Re: Sub-Petition No. 1293-BR-02 - Request for Access Road Change in Redding

Change in Access Road from Windy Hill Road to Umpawaug Road in Redding for structure #2911

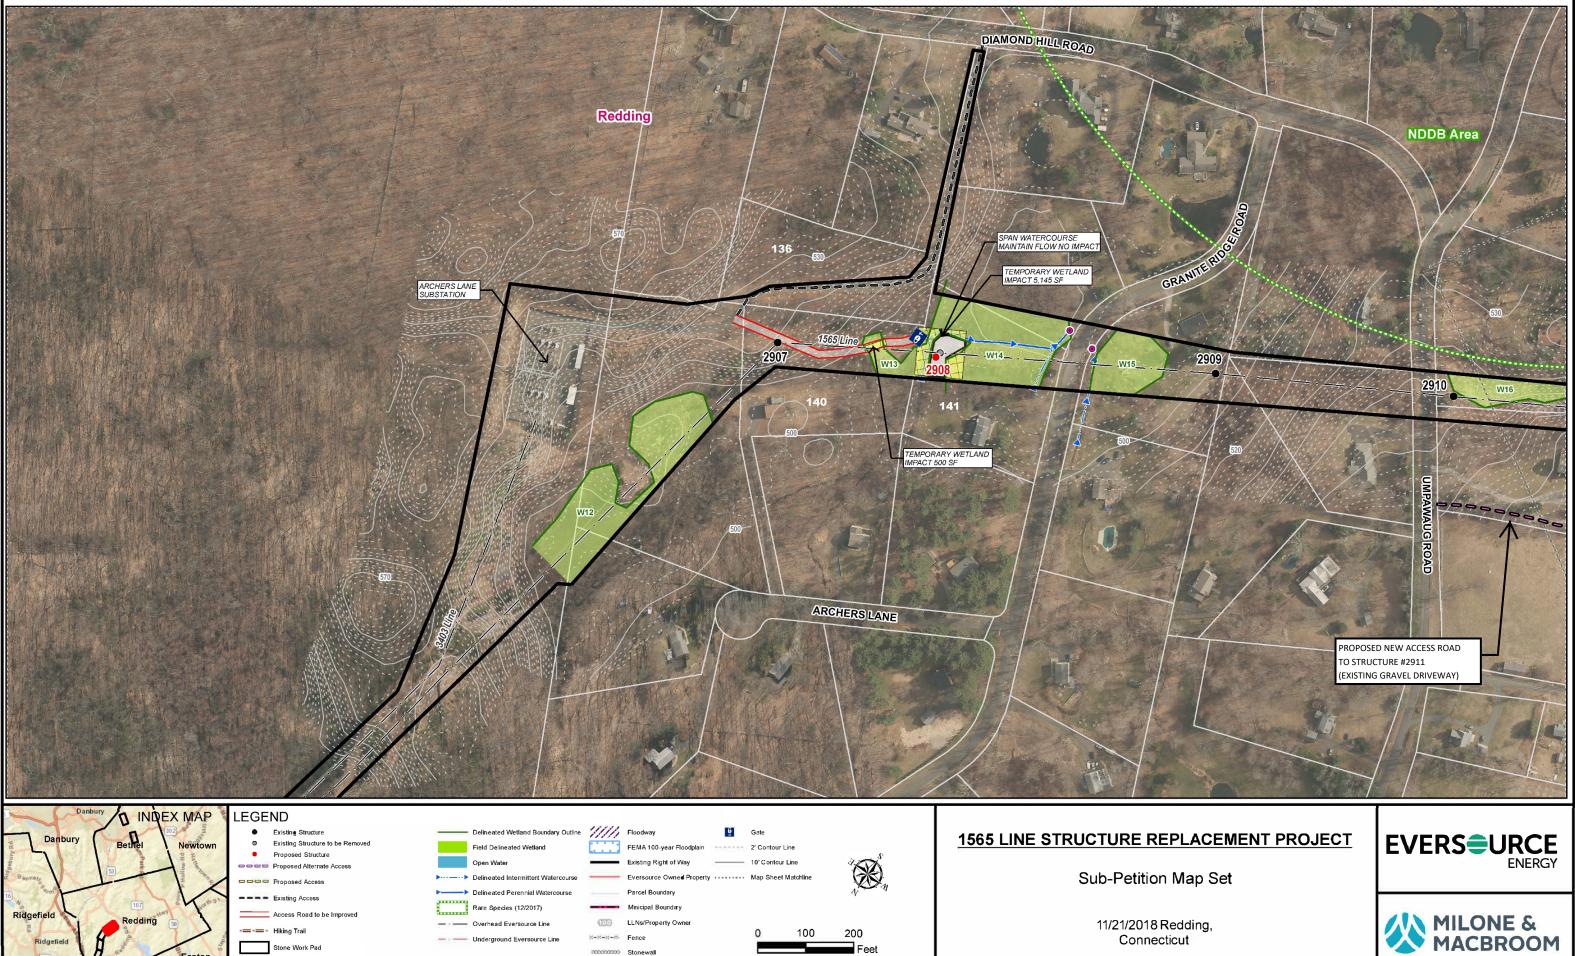
The requested access road change is located at 159 and 161 Umpawaug Road, Redding, just north of the Eversource ROW. This The location is shown as "Proposed New Access Road" on the revised Map Sheets 3 and 4 dated November 21, 2018 (see Attachment A).

In the sub-petition filing, Eversource had shown access to structure 2911 by entering the Eversource ROW off Windy Hill Road and constructing a temporary access road between structures 2912 and 2911. This temporary access road would have required crossing a large wetland area and Cemetery Brook and traversing a steep hill adjacent to a residential property. After further discussion with the property owner it has been determined that the access road between structure 2912 and 2911 could be eliminated by utilizing an existing gravel driveway located at 159 and 161 Umpawaug Road and necessary access rights have been secured. The driveway extends from Umpawaug Road toward the Eversource ROW and terminates approximately 100 feet from structure 2911. A short section of the proposed access road would be improved with gravel then restored to original condition upon completion of the Project. The use of the existing driveway would eliminate the wetland and watercourse crossing and avoid traversing the steep hill. Windy Hill Road would still be utilized to access structure 2912.
